PLANNING COMMISSION STAFF REPORT
100 S GARFIELD STREET SUBDIVISION – PRELIMINARY PLAT – SUB322-0001

FILE NO: SUB322-0001

REQUEST: Subdivide a 1.93acre (84,022 sq ft) property into 12 lots for residential homes

MITIGATION & RE-PLANTING PLAN
12-LOT SUBDIVISION

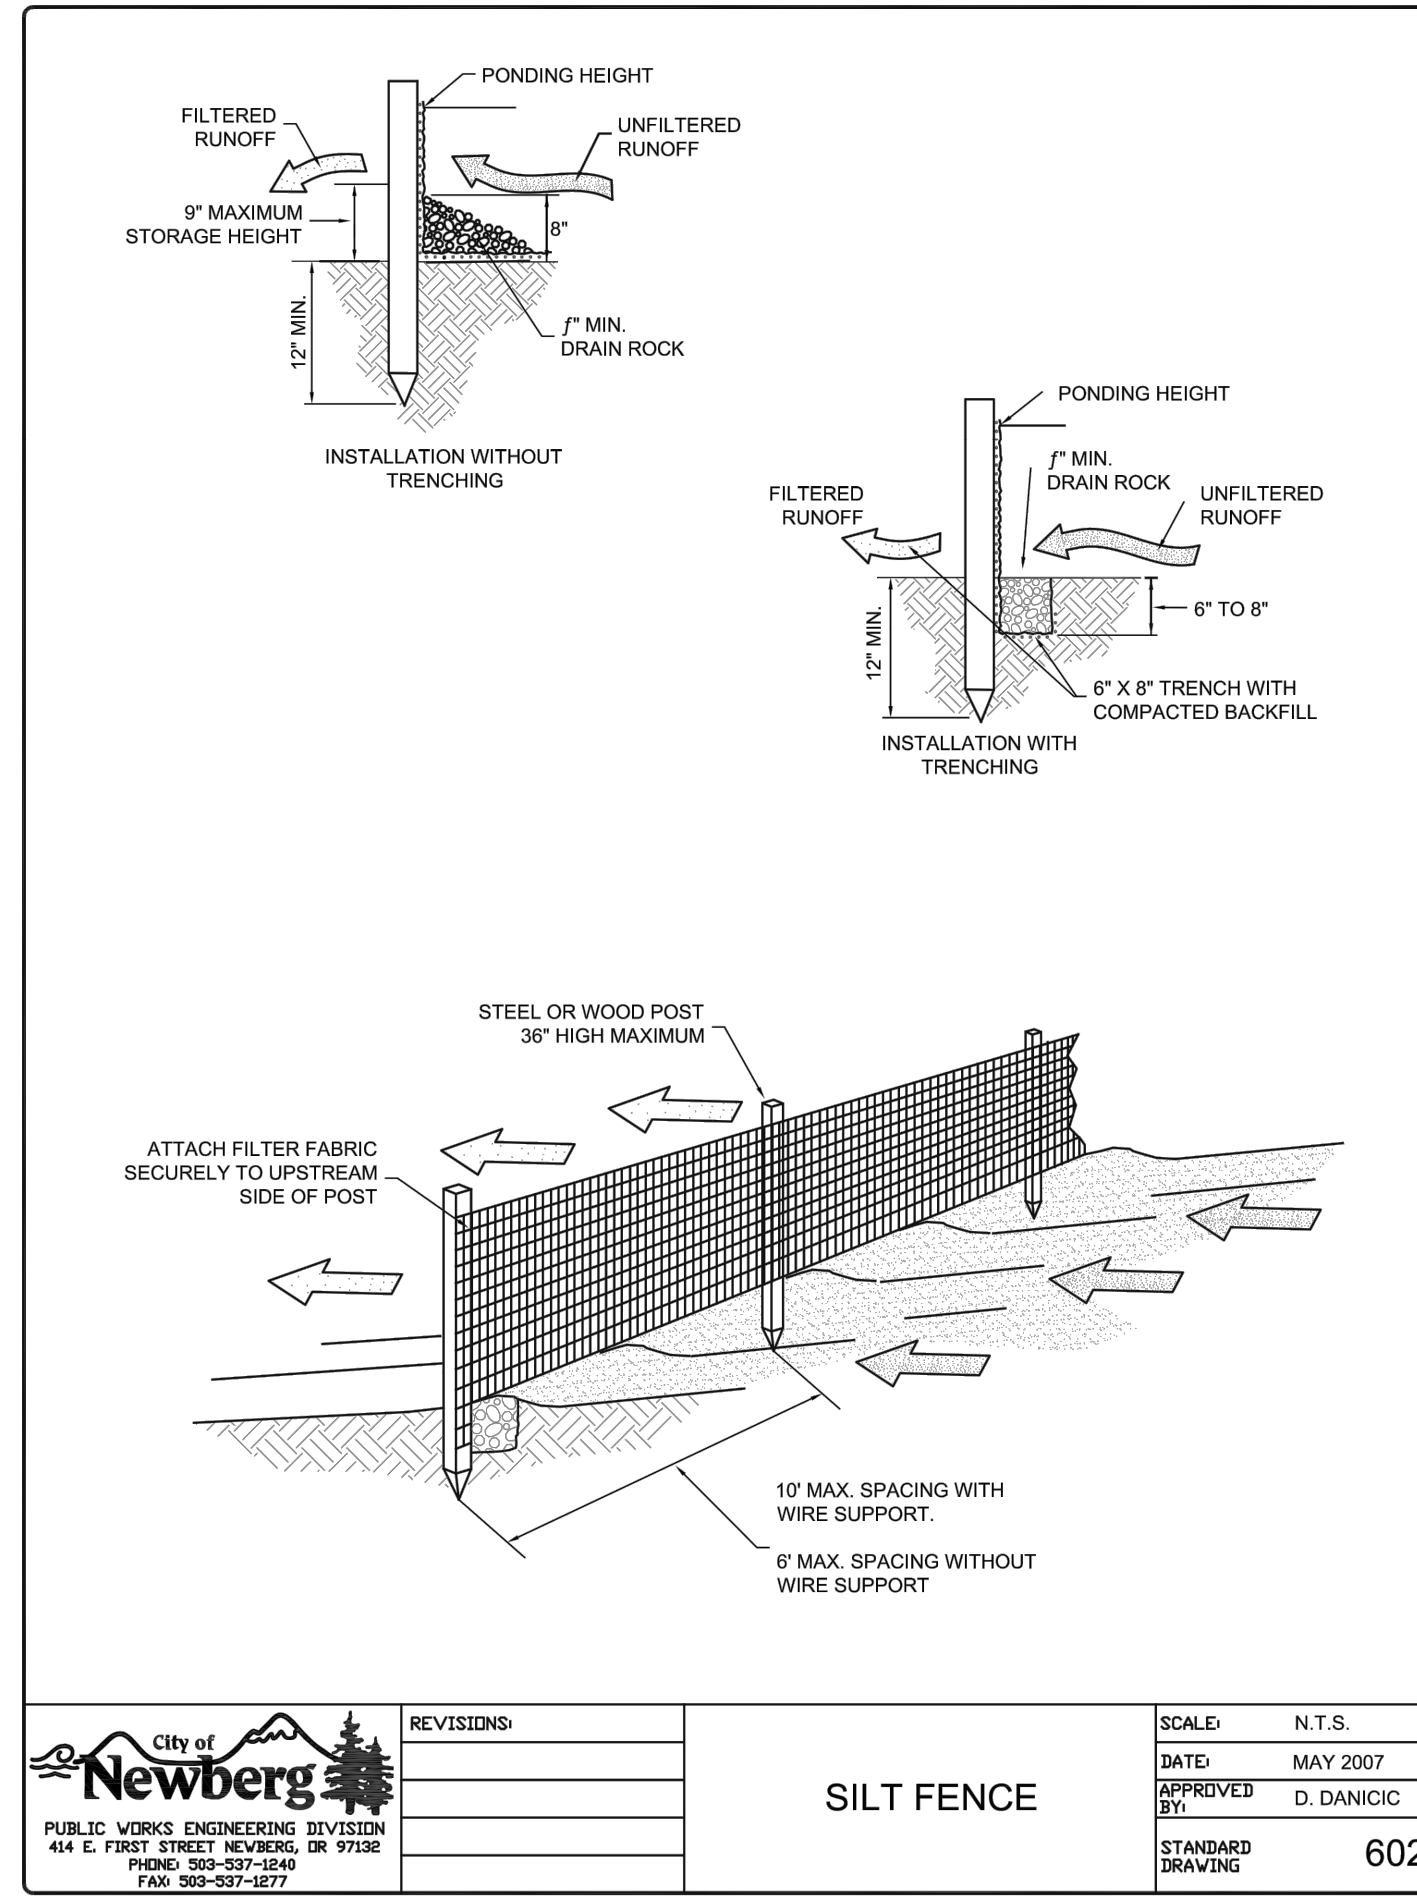
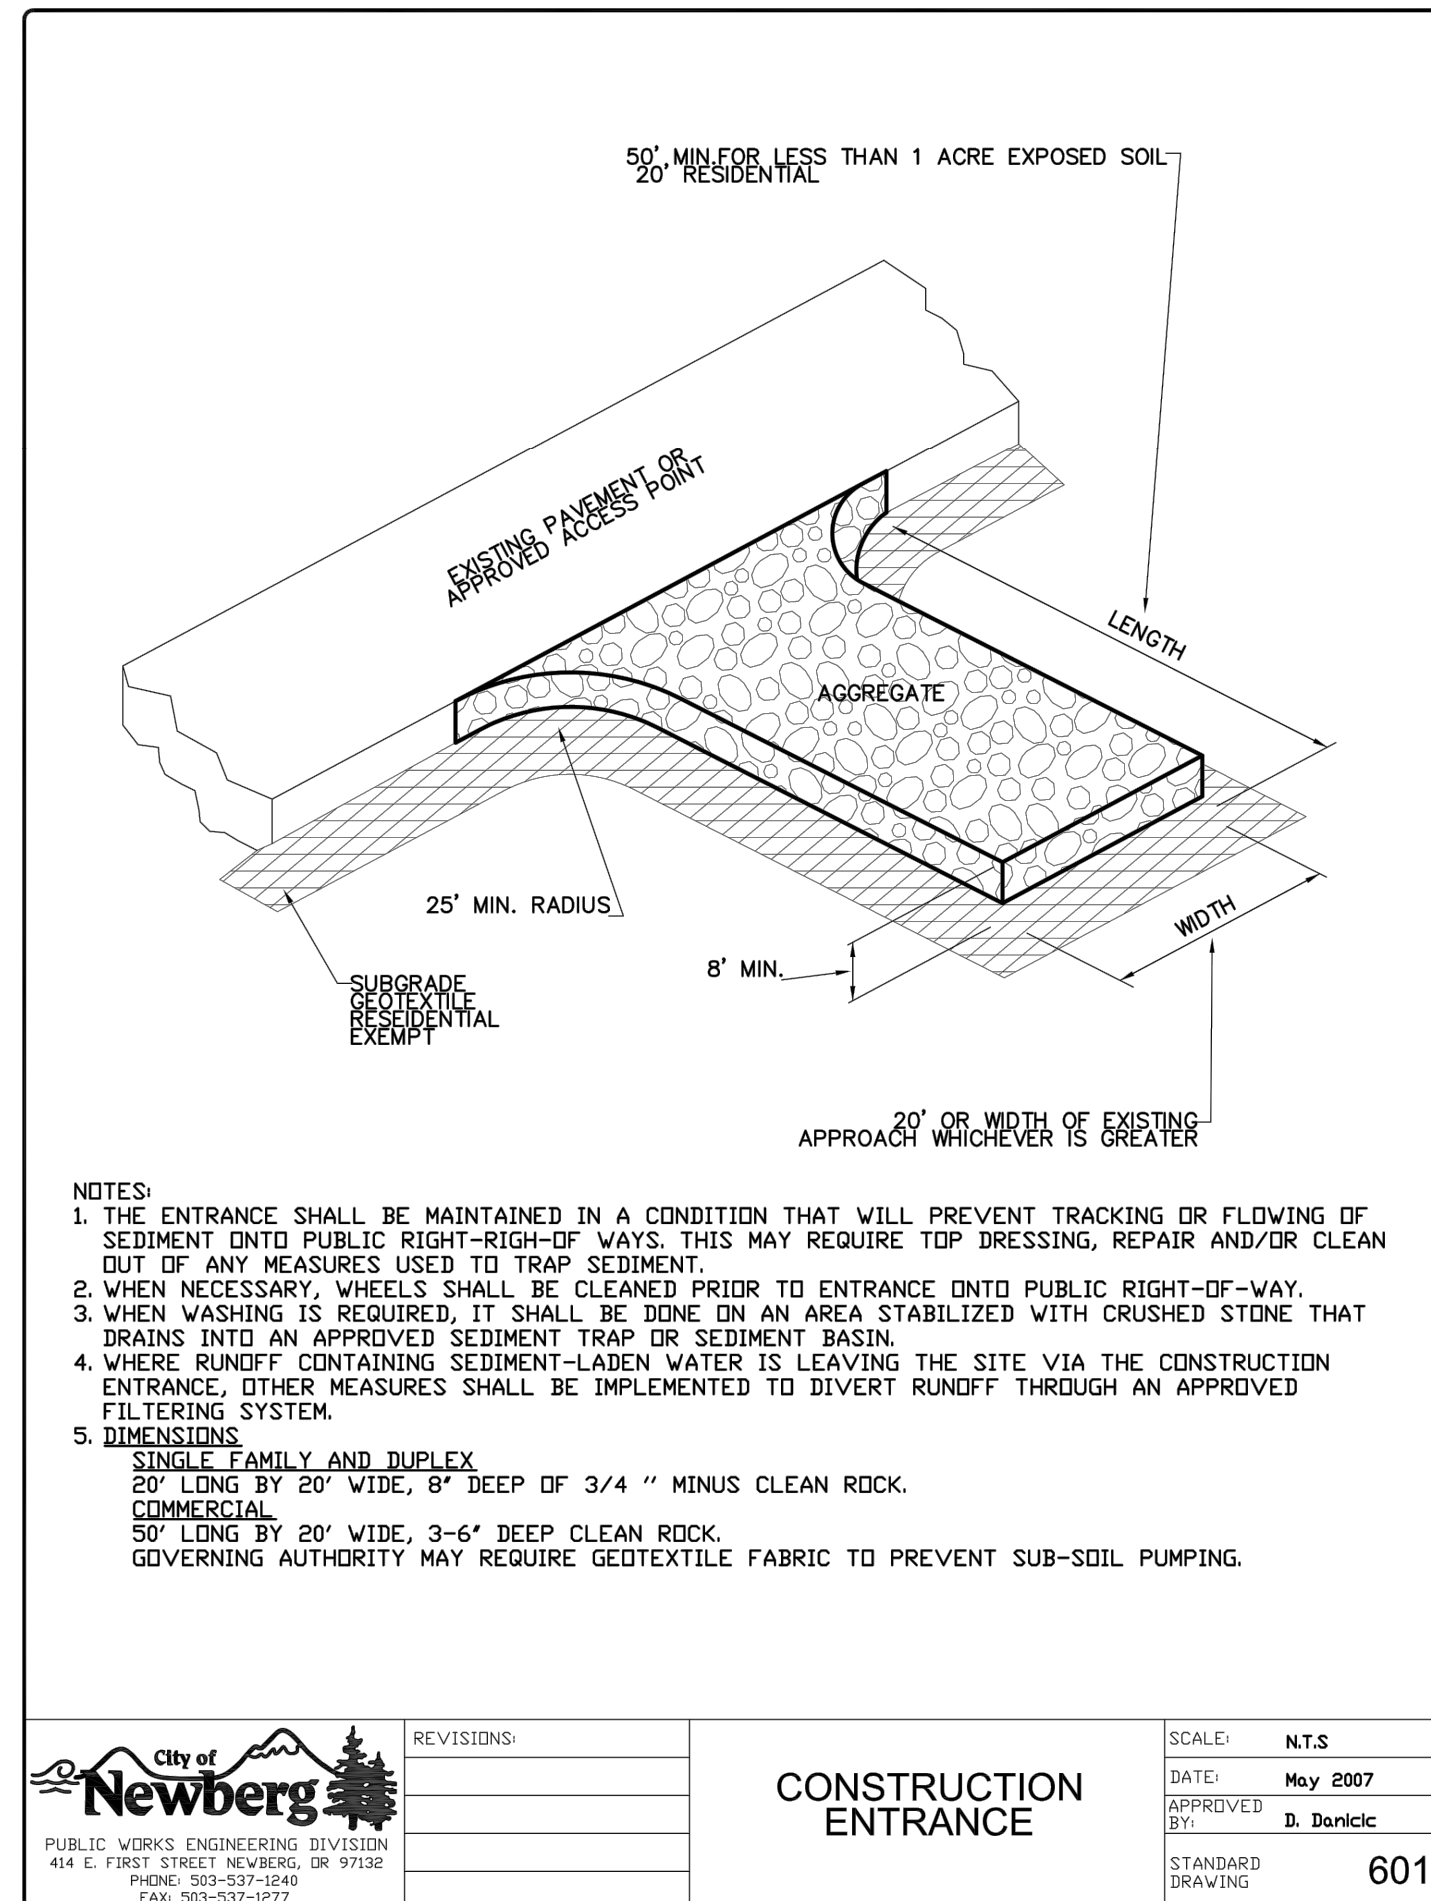
Finding: The applicants narrative states they will comply with all mitigation requirements for Type II activities, however, it was determined that this proposal most closely fits the Type I activities listed in NMC 15.342.040(B) as described in the previous finding. The mitigation requirements for Type I and Type II vary slightly. The applicant's mitigation and replanting plan noted on sheet 6 of submitted

plans meet all the requirements for a Type I mitigation plan. The only subsection not noted was subsection C regarding the removal of trees over six inches. It is unclear if trees of this size will be removed. If trees over six inches in diameter, as measured at breast height are to be removed, they shall be replaced at a ratio of three new trees for every one removed. All trees replaced pursuant to this section shall have an average caliper measurement of a minimum of one inch. Additional trees of any caliper may be used to further enhance the mitigation site.
